Subject: Waterford 3 SES
Docket No. 50-382
License No. NPF-38
Technical Specification Change Request NPF-38-230
Revision of RCS Cooldown Requirement

**TECHNICAL SPECIFICATION CHANGE REQUEST
REVISION OF RCS COOLDOWN REQUIREMENT**

WESTINGHOUSE REPORT ER-WS-PS-0001, REV 000
IMPROVEMENT OF TECHNICAL SPECIFICATION RCS COOLDOWN LIMITATIONS

FIGURE 3.4-3

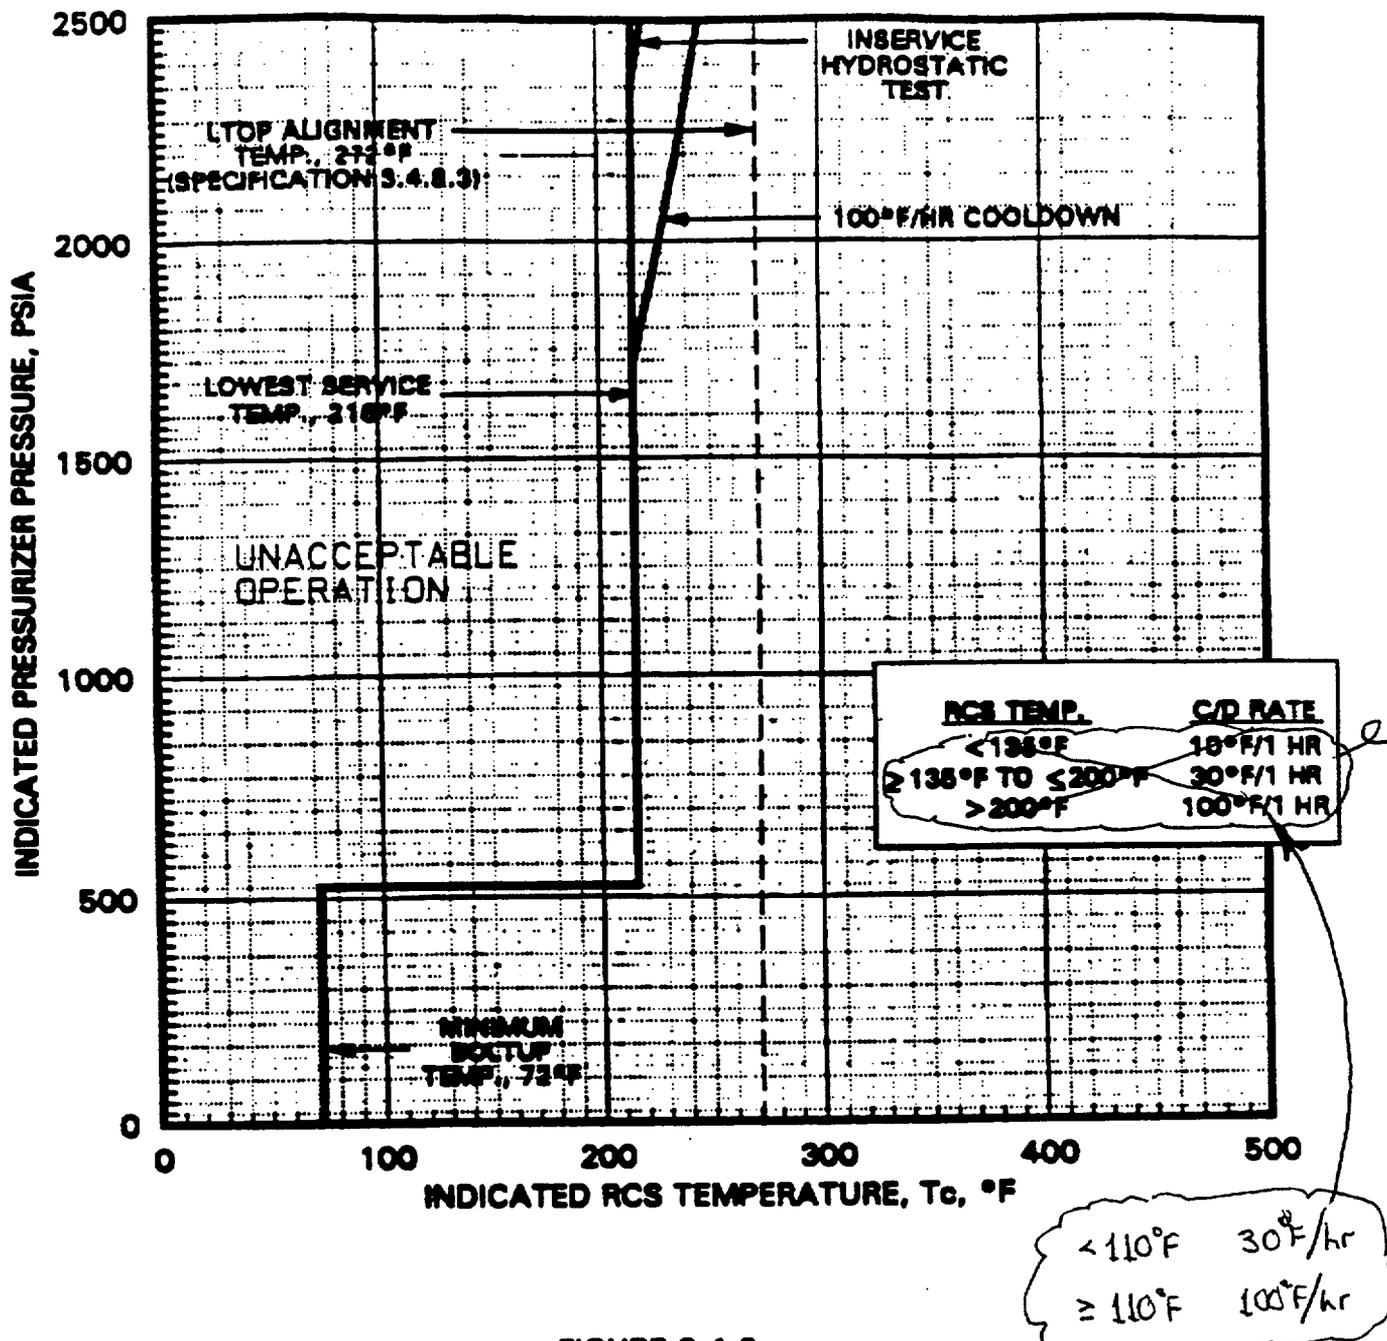
Waterford 3 proposes to amend its Operating License by modifying the Limiting Condition for Operation for Technical Specification (TS) 3.4.8.1 and Figure 3.4-3. The requested changes will revise the Reactor Coolant System (RCS) cooldown limitations to eliminate the 10°F per hour restriction at RCS temperatures below 135°F. The new cooldown rate steps are proposed as 100°F per hour at RCS temperatures down to and including 110°F and 30°F per hour limit at RCS temperatures below 110°F.

- c. A maximum heatup rate of 60°F per hour with Reactor Coolant System cold leg temperature greater than 345°F.
- ~~d. A maximum cooldown rate of 10°F per hour with Reactor Coolant System cold leg temperature less than 135°F.~~

- d g. A maximum cooldown rate of 30°F per hour with Reactor Coolant System cold leg temperature ~~greater than or equal to 135°F and less than or equal to 200°F.~~ 110°F

- e f. A maximum cooldown rate of 100°F per hour with Reactor Coolant System cold leg temperature greater than ~~200°F.~~ or equal to 110°F
- f g. A maximum temperature change of less than or equal to 10°F in any 1-hour period during inservice hydrostatic and leak testing operations above the heatup and cooldown limit curves.
